**MASTER DEVELOPMENT
DRAINAGE PLAN
FOR
ESTEBAN RODRIGUEZ SUBDIVISION SKETCH PLAN,
EL PASO COUNTY, COLORADO**

February 2024

PCD File No.: SKP237

This document is the Master Development Drainage Plan (MDDP) for the proposed Esteban Rodriguez Subdivision Sketch Plan. The purpose of this drainage plan is to:

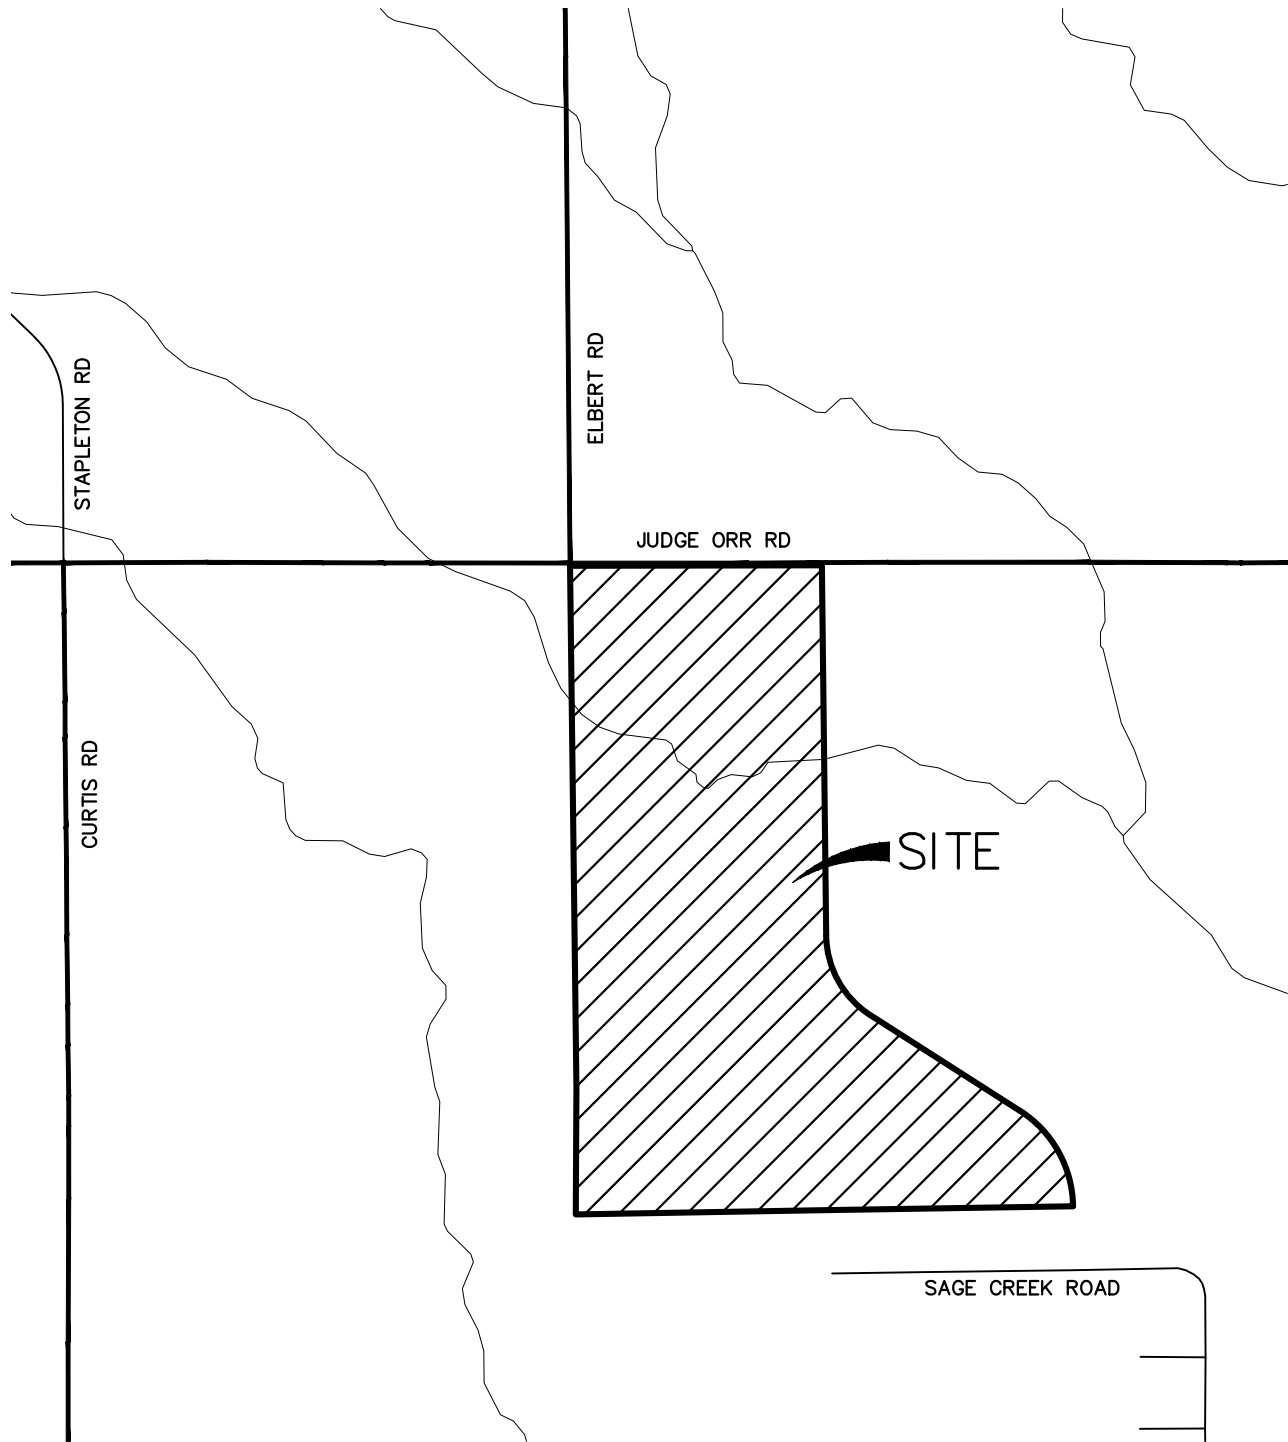
Review 1: Although indicated that flows will be released at less than historic, they are also concentrated instead of historic sheet flow conditions. Please discuss and analyze the downstream conditions of each of the outfall points (see DCMV1 Ch4.2).
Review 2: unresolved.

Review 1 comment:
Provide preliminary analysis of the channel and identify anticipated infrastructure needed at the road crossings and any other improvements needed to stabilize the channel.
Review 2: unresolved. Please provide a preliminary analysis of the channel and identify issues, stabilization design, anticipated infrastructure needed at the road crossings etc.

JR Response: See the basin descriptions for the information about the outfalls and downstream conveyance.

JR Response: Provided preliminary analysis of the channel and anticipated infrastructure at roadway crossing. See "Channel Analysis and Design" section.
